Subregional RTEP Committee – Western FirstEnergy Supplemental Projects

July 19, 2024

ATSI Transmission Zone M-3 Process Ayersville Weston Network and 69 kV Conversion Project - s1953 Scope Change

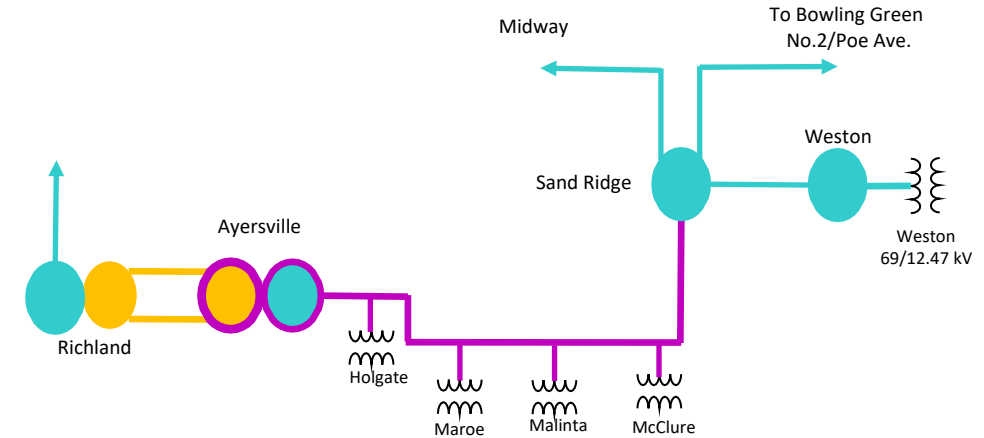
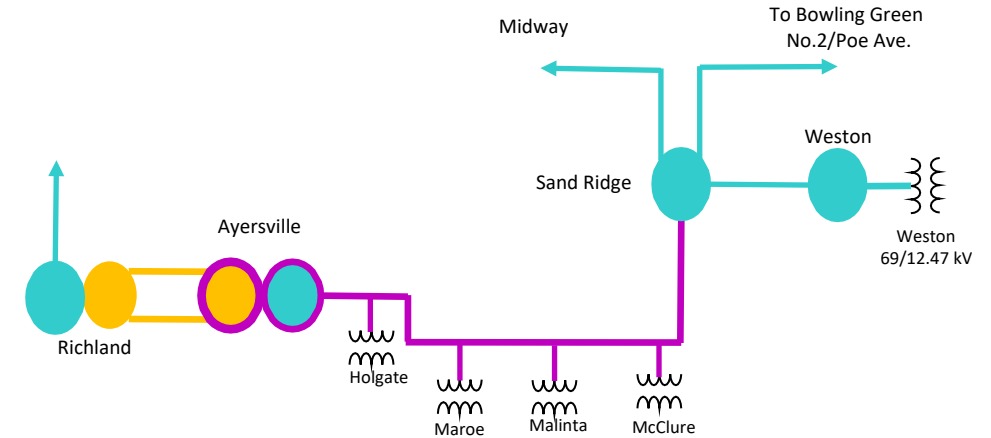
Reason for Scope Change: FE unable to secure property for the expansion of the Weston Substation due to landowner concerns. Through community engagement, FE able to secure a property 600 feet west of the existing Weston Substation to build a new four (4) breaker ring bus station (Sand Ridge).

- ~~Weston Substation: Expand Weston substation to a four (4) breaker, future six (6) breaker ring bus with 69 kV line exits for the new Ayersville line, and the Midway and Tontogany 69 kV lines. Remove all 34.5 kV equipment post conversion (ex: Weston 69/34.5 kV transformer #3, circuit breakers, ...etc.).~~

- **Sand Ridge Substation:** Build a new four (4) breaker, future six (6) breaker ring bus with 69 kV line exits for the new Ayersville line, the Midway and Bowling Green No.2 69 kV lines, and the Weston 69 kV line.

- A new 69 kV tie line from Sand Ridge Substation to Weston Substation will be constructed using the same conductor as Ayersville – Sand Ridge 69 kV proposed line rebuild.

- **New Ayersville-~~Weston~~ Sand Ridge 69 kV Line:**
 - Build new 5.6 miles 69 kV line to network Ayersville-Maroe and Weston-Malinta radial lines.
